RE: Broken Arrow Investments, LLC – Derr Pit – Technical Revision No. 8 Adequacy Review 2 Response – File No. M-2008-017

Broken Arrow Investments, LLC has received the Division's Adequacy Review 2 of the Technical Revision No. 8 Request letter dated April 19, 2023. Below are the comments and the corresponding responses that we have provided to address the comments.

Adequacy Review 2 Comments

P:\07123 Derr Gravel Pit\Drawings\Mining Plan\2018∖JT-Derr 2018 Mining C-2.dwg, MPlan, 4/21/2023 9:36

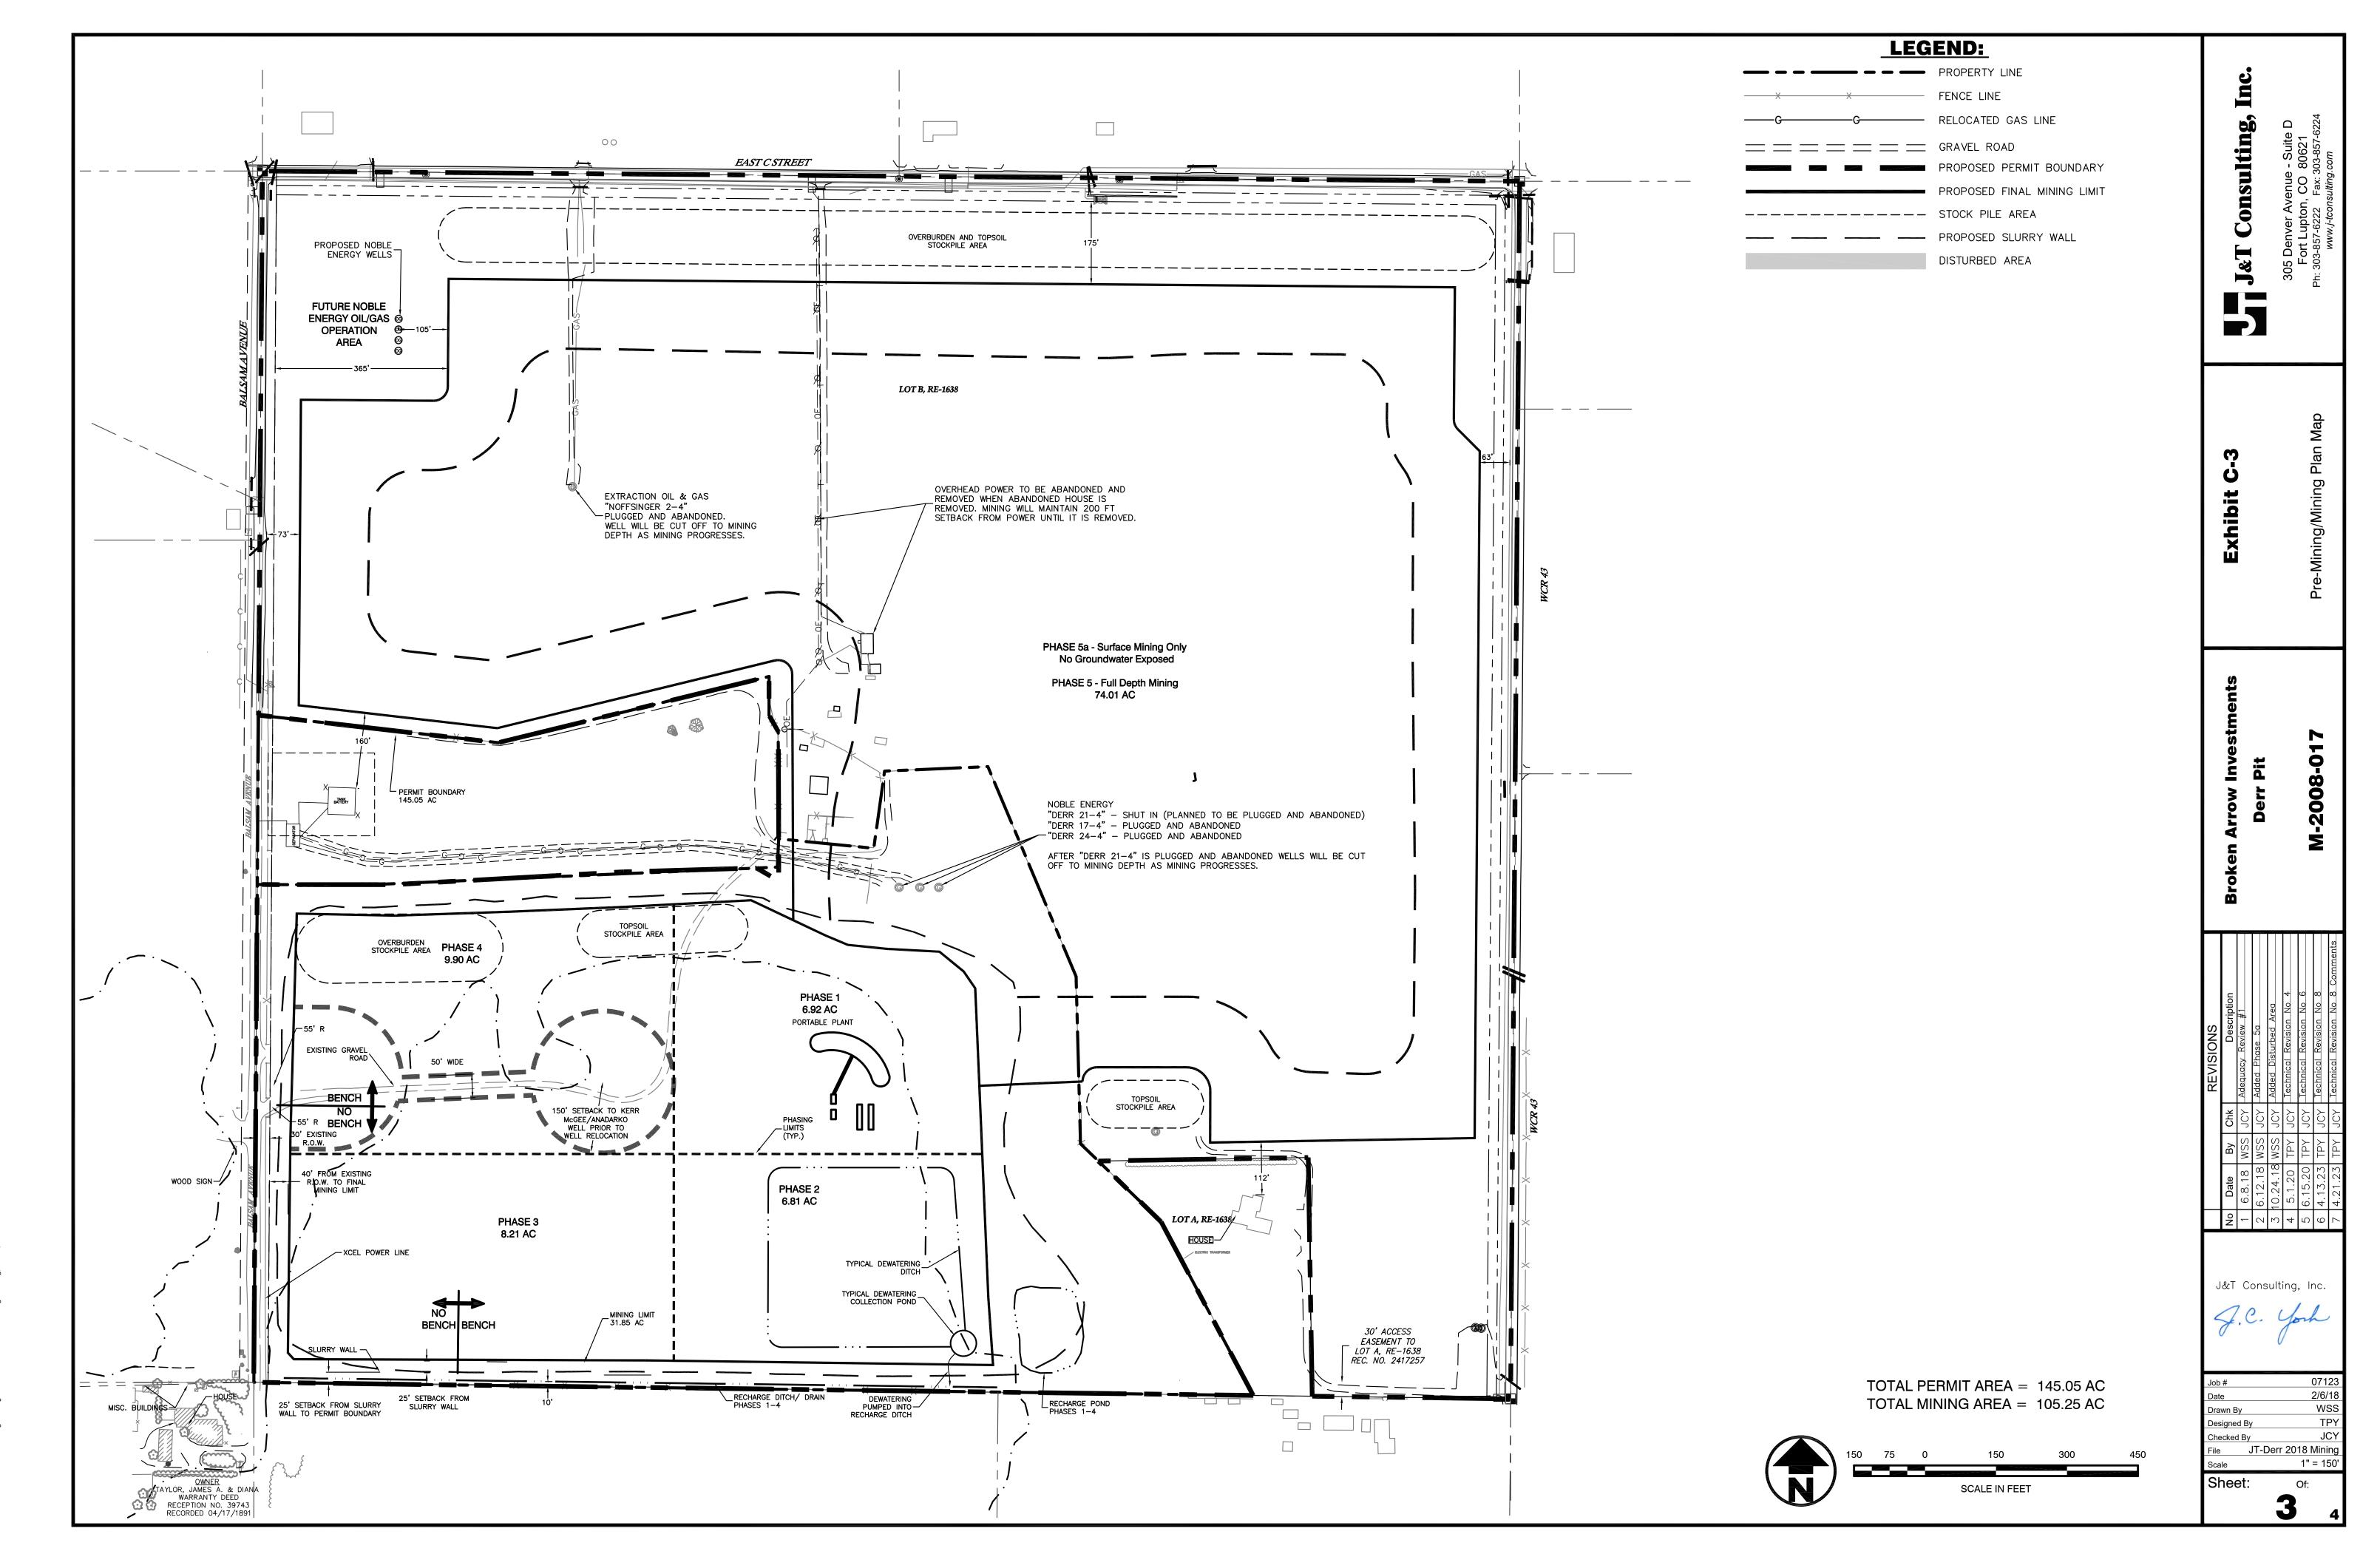
1. Contour data on the Stability Section Map provided appears to be much more recent than the contour data provided on the Exhibit C-1 Existing Conditions/Mining Plan map (as well as other figures where contour data is shown). Please update the contour information on the existing conditions map (and other maps) to be as current as possible at this time.

2. Please show locations and anticipated volumes of topsoil and overburden locations for Phase 5a/5 on the mine plan map if you wish to use locations other than what are currently shown to minimize haul distances.

Response: An updated Mining Plan Map has been provided with the attachments to this letter showing the same contour data provided in the slope stability report.

Response: An updated Mining Plan Map has been provided with the attachments to this letter showing the locations for the topsoil and overburden stockpiles.
